<b>Title - Sujet</b> HEADQUARTERS SHELTER SYSTEMS (HQSS)		
<b>Solicitation No. - N° de l'invitation</b> W8476-155245/A		<b>Amendment No. - N° modif.</b> 004
<b>Client Reference No. - N° de référence du client</b> W8476-155245		<b>Date</b> 2015-05-27
<b>GETS Reference No. - N° de référence de SEAG</b> PW-\$\$QF-112-25083		
<b>File No. - N° de dossier</b> 112qf.W8476-155245	<b>CCC No./N° CCC - FMS No./N° VME</b>	
<b>Solicitation Closes - L'invitation prend fin</b> <b>at - à 02:00 PM</b> <b>on - le 2015-07-29</b>		<b>Time Zone</b> <b>Fuseau horaire</b> Eastern Daylight Saving Time EDT
<b>F.O.B. - F.A.B.</b> <b>Plant-Usine:</b> <input type="checkbox"/> <b>Destination:</b> <input checked="" type="checkbox"/> <b>Other-Autre:</b> <input type="checkbox"/>		
<b>Address Enquiries to: - Adresser toutes questions à:</b> Mercier, Michel		<b>Buyer Id - Id de l'acheteur</b> 112qf
<b>Telephone No. - N° de téléphone</b> (819) 956-4015 ( )		<b>FAX No. - N° de FAX</b> ( ) -

**Amendment No. 004**

This amendment is raised to provide some answers to questions submitted by Bidders.

Reference: Third Party Verification Test Plan, Appendix BB, Annex B,

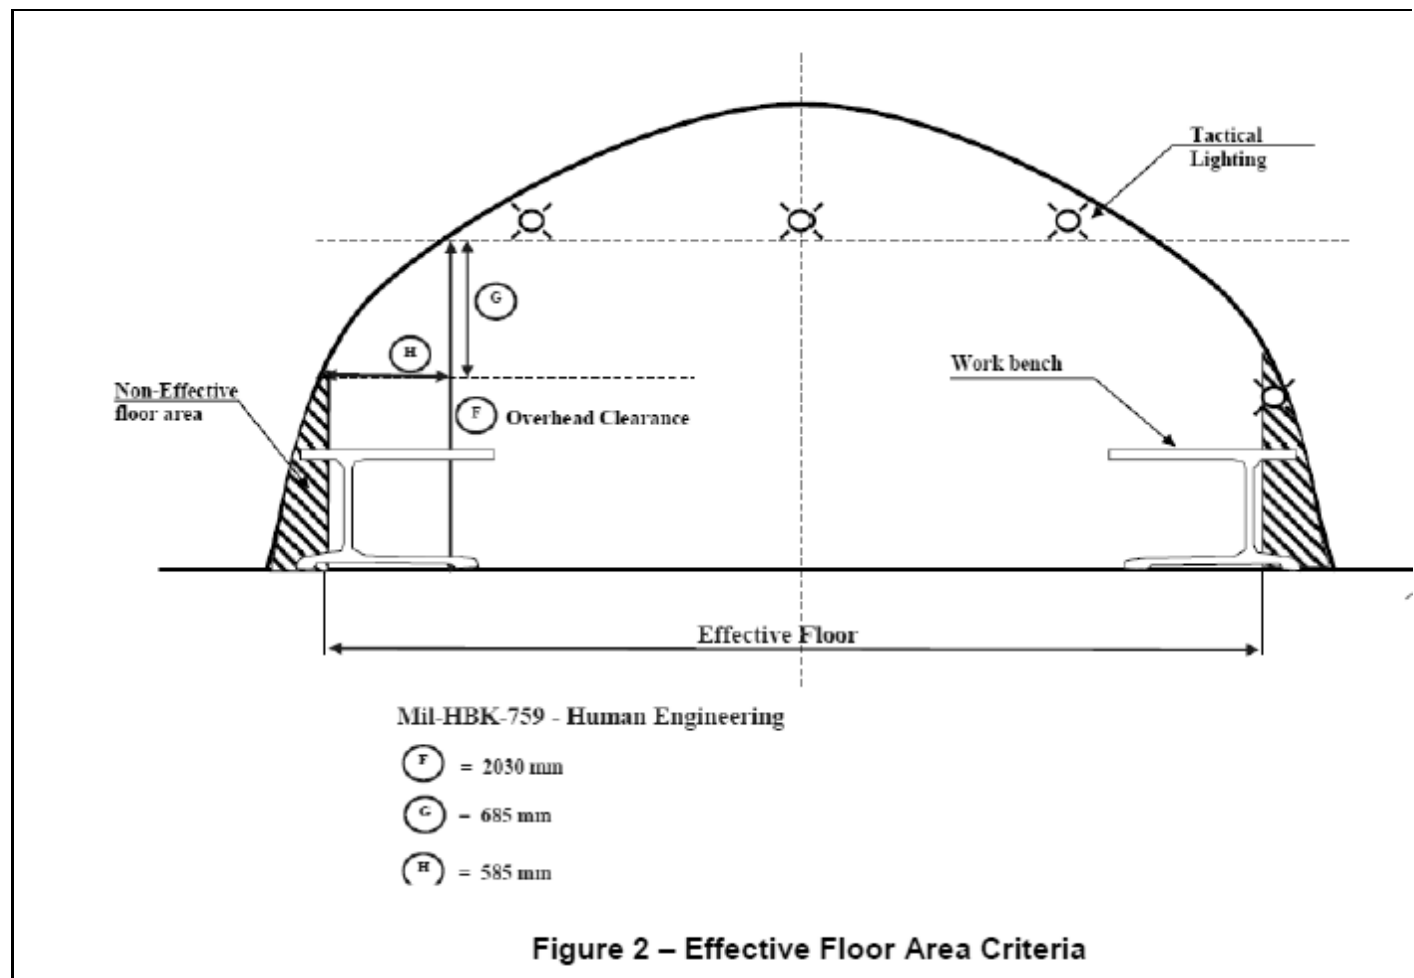
Volume 1, Section 6.3.7 Verification Procedure, Page 23 6.3.7.1 Effective Floor Area - The effective floor area shall be measured by Third Party personnel as per the criteria shown in Figure 2 – Effective Floor Area Criteria, and verified by DND personnel.

The definition of Effective Floor Area in the HQSSRVM matches that in HQSS Acquisition and In-Service Evaluation, Appendix BA,

Annex B, Volume 1, Table 5, page 27, but does not match that in Appendix BB - Third Party Verification, page 22 of 48. It would be impossible to produce Figure 2 from section 6.3.7.1 in Appendix BB - Third Party Verification from the description of Effective Floor Area in the HQSSRVM combined with

MIL-HDBK-759. Figure 2 allows a portion of the Effective Floor Area to be a reduced height space, which isn't implied by the HQSSRVM, Appendix BA - Technical Bid Evaluation, or MIL-HDBK-759.

MILHDBK-759 has no section related to the Effective Floor Area of shelters. Would DND please confirm which method of determining Effective Floor Area is correct?

"2.2.1 The Effective Floor Area of the Operations Shelter, Planning Shelter, Office Shelter, Shelter Connector Hub, Vehicle Boot, and Black-out Vestibule shall be defined as that area with an enclosed clear height of at least 2030 mm, maximum overhead reach of 685 mm and maximum depth of reach of 585 mm when the Shelter is set up on top of a flat level surface with the Semi-Rigid Flooring in accordance with paragraph 4, and Soft Flooring in accordance with paragraph 2.5, installed."
